## SPEEDWAY (14 MILE & HAGGERTY) JSP17-63

### Speedway JSP17-63 with Rezoning 18.720

## PLAN REVIEW CENTER REPORT

Rezoning Request from OST (Office Service Technology) & B-3 (General Business) to B-3 (General Business) with Planned Rezoning Overlay (PRO) – First Revised Concept Plan

**PLOT PLAN**  
**REBUILD**  
 31275 HAGGERDY ROAD  
 OAKLAND COUNTY  
 NOVI, MI

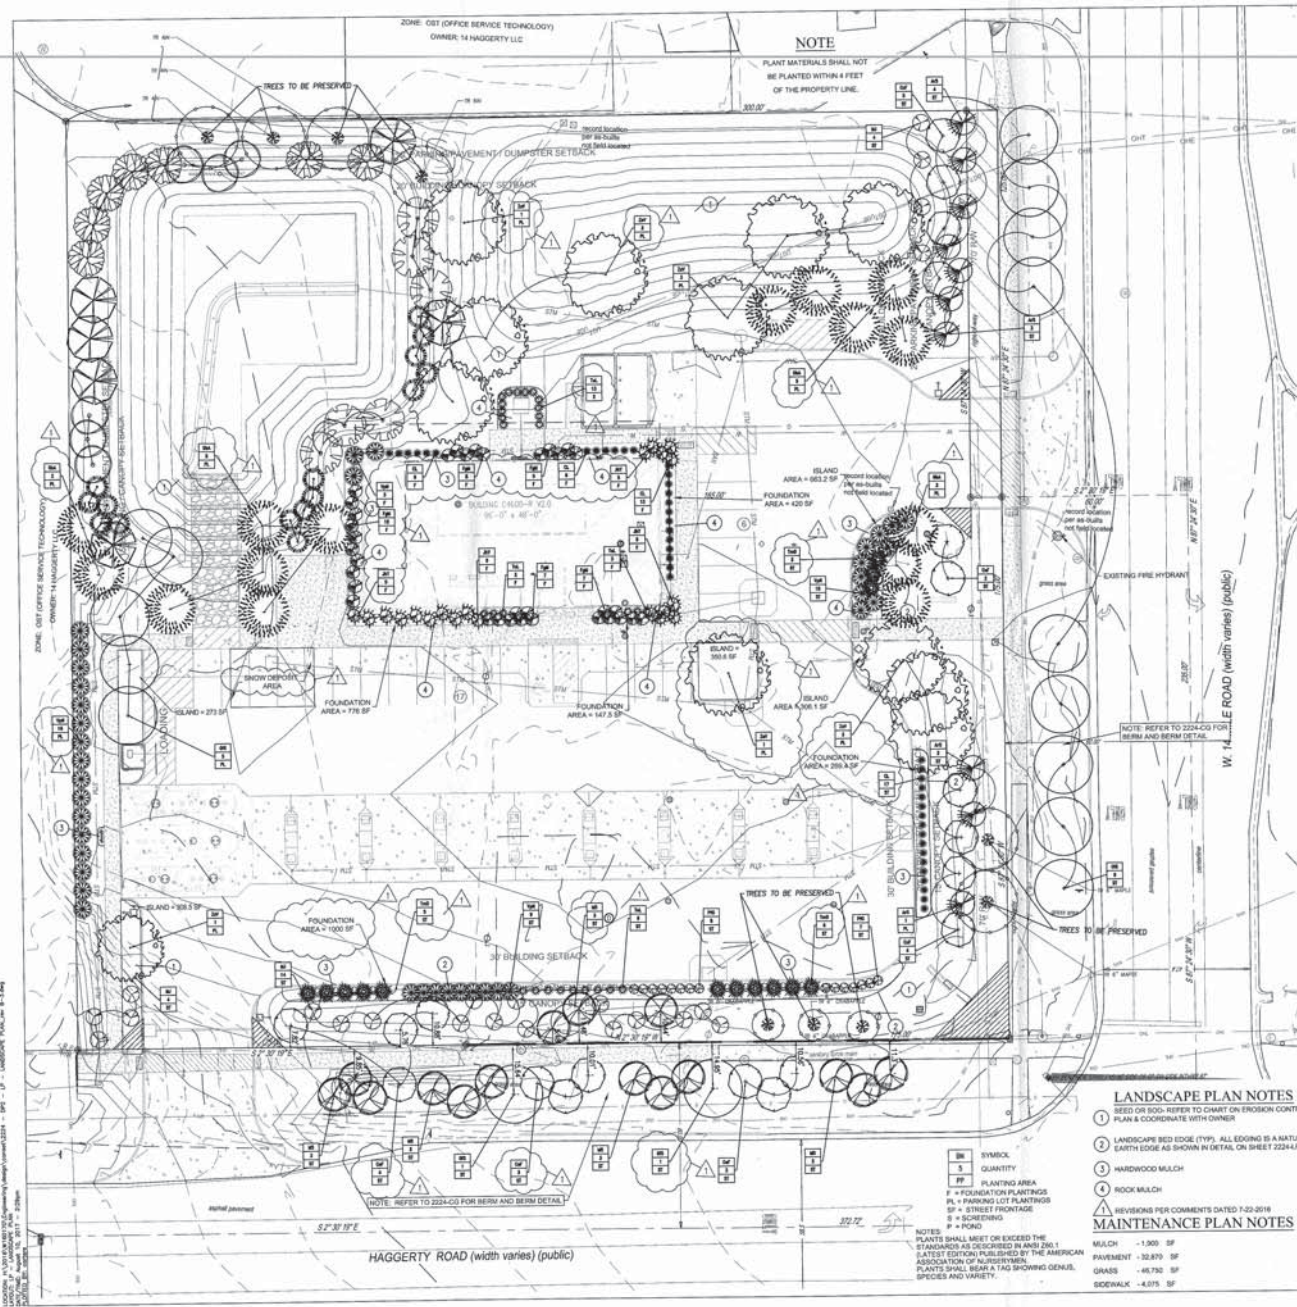
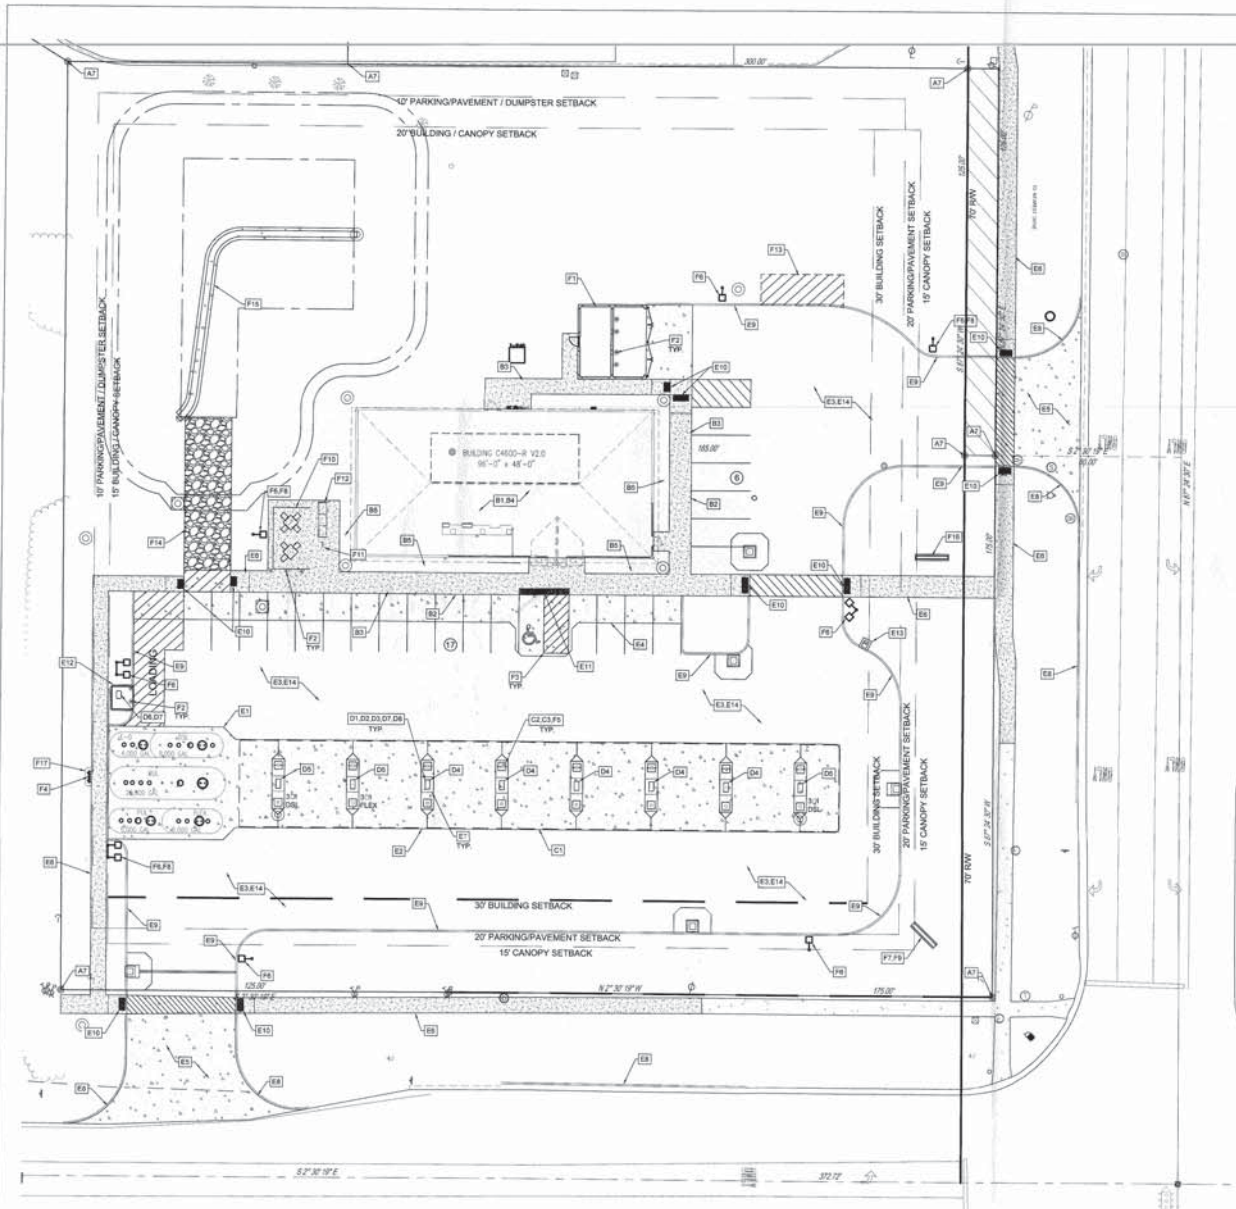
The Concept Plan does not meet the general requirements of Chapter 11 of the Code of Ordinances, the Storm Water Management Ordinance and/or the Engineering Design Manual. The following items must be addressed prior to resubmittal:

1. Revise the grading, storm sewer, and drainage areas to capture the southeastern portion of the paved areas of the site. On-site storm water must be detained.
2. Provide a drainage area map as part of the Storm Water Management Plan.

18. Minimum storm sewer size is 12-inch in all areas capturing impervious surface runoff.
19. Provide a drainage area map and clarify how the canopy area runoff is captured and conveyed, showing what structures connect to pipe #13.

42. The proposed driveway width of 35 feet exceeds the standard commercial driveway width. Revise the driveway to standard width as described in Section 11-216 and Figure IX.1 of the Design and Construction Standards. A request for variance from the Design and Construction Standards for a driveway width within the allowable range shown in Figure IX.1 can be approved administratively with appropriate justification.

43. The proposed driveway opening on Haggerty Road is located in the existing taper. The driveway opening should be relocated and/or the existing lane and taper modified to properly accommodate the curb cut.

3. Sidewalk Requirements
- a. The applicant should provide details for the proposed sidewalks and ramps.
    - i. The sidewalk width dimensions on sheet CS1 do not coincide with note E6 on sheet CS. Update accordingly.
